## **STAFF REPORT**

DATE: 3/25/2019

**TO:** Planning Commission  
**FROM:** Ken Roberts, Planning Director  
**AGENDA ITEM:** The Legacy at North Star Second Addition – Easement Vacations and Final Plat and PUD Plans  
**REVIEWED BY:** Jack Griffin, City Engineer

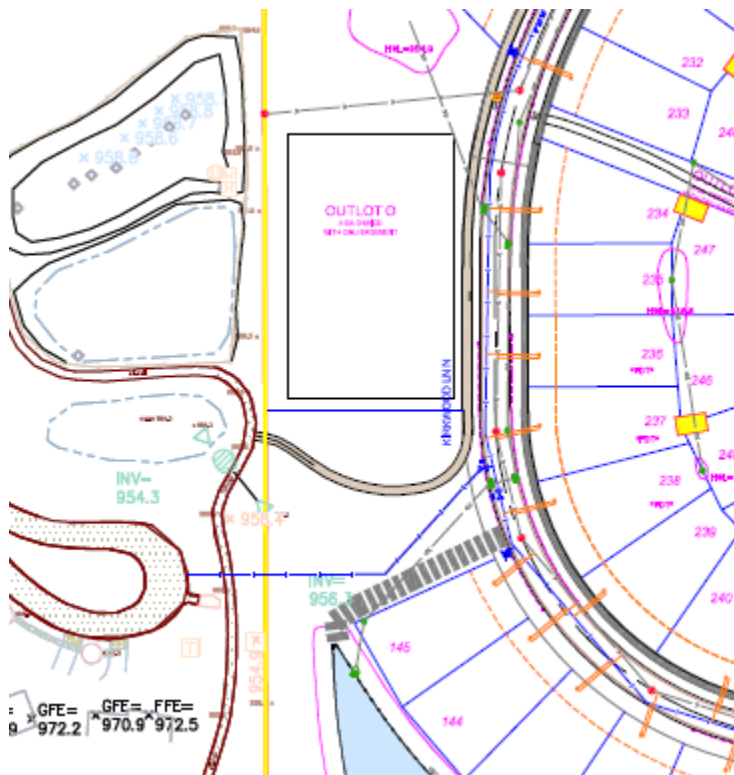
**Landscaping and Tree Preservation.** Staff submitted the proposed project landscape plans to the City's Landscape Architect for review. It is a recommended condition of approval that the landscape plans be approved before recording of final plat.

The applicant also provided a tree preservation plan. The preliminary landscape plans indicated that there were no trees on the site and therefore no removal. However, trees were removed on the western edge of the property during grading. The tree preservation plan shows that three significant trees were removed. The applicant will be required to replace these trees per the tree preservation ordinance and has indicated that conversations have been had with adjacent property owners indicating that larger trees will be planted along this western edge to screen these properties as much as possible.

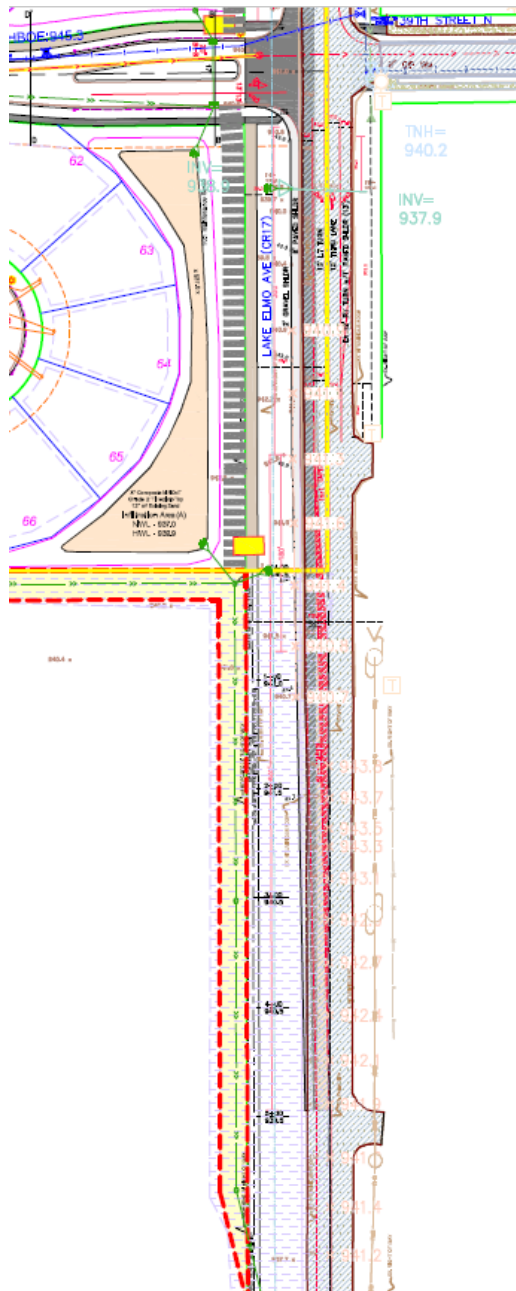
**Trails.** It was a condition of preliminary plat approval that the applicant provide a trail connection to the Hamlet on Sunfish Lake trails plat, as shown below. This trail connection runs along 39<sup>th</sup> Street and will connect the Hamlet on Sunfish Lake trails to Lake Elmo Avenue. The applicant and City have worked with the Hamlet on Sunfish Lake residents to determine this connection point. These trails are still private and it is unknown whether or not these trails will be made public.

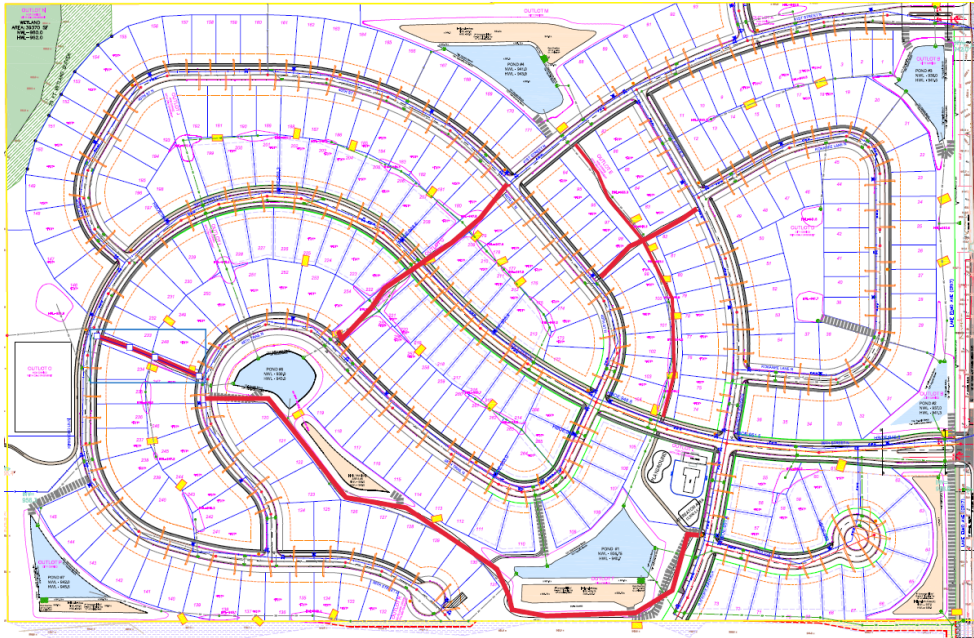
Another condition was that a trail be provided from 39<sup>th</sup> Street to the southern limits of the plat and that the future County right-of-way area along Lake Elmo Avenue of the parcel to the south of the plat be graded for a future bituminous trail extension (grade ready trail) along the storm sewer outfall pipe location.

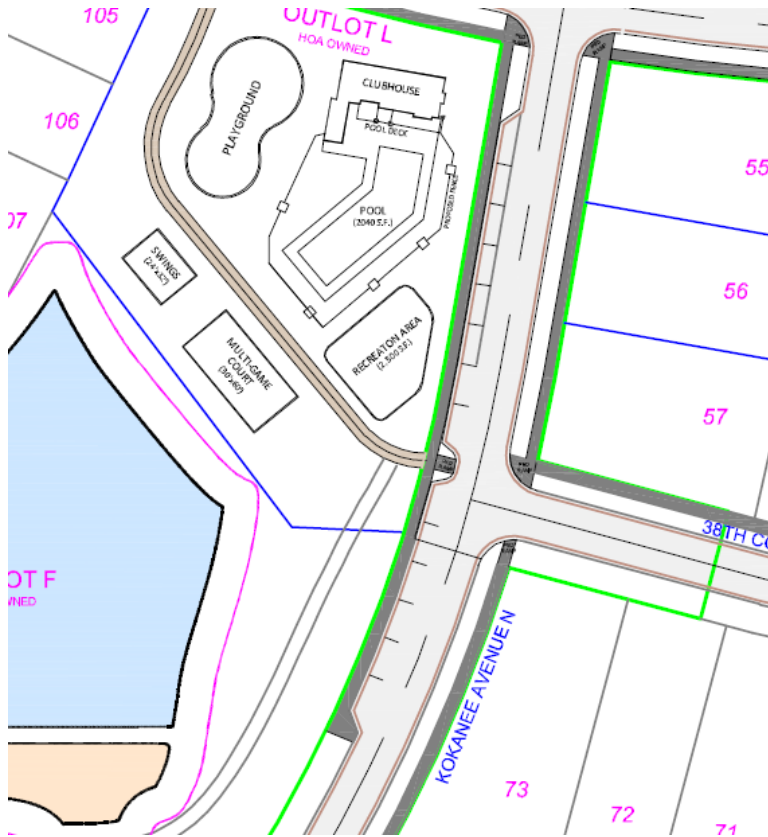
- 13. That wetlands and wetland buffer areas be contained within outlots outside of lot areas and dedicated to the City.*

The preliminary plat shows that with buffer averaging this wetland buffer has been contained within Outlot N of the preliminary plat. This condition is not applicable to the Second Addition.
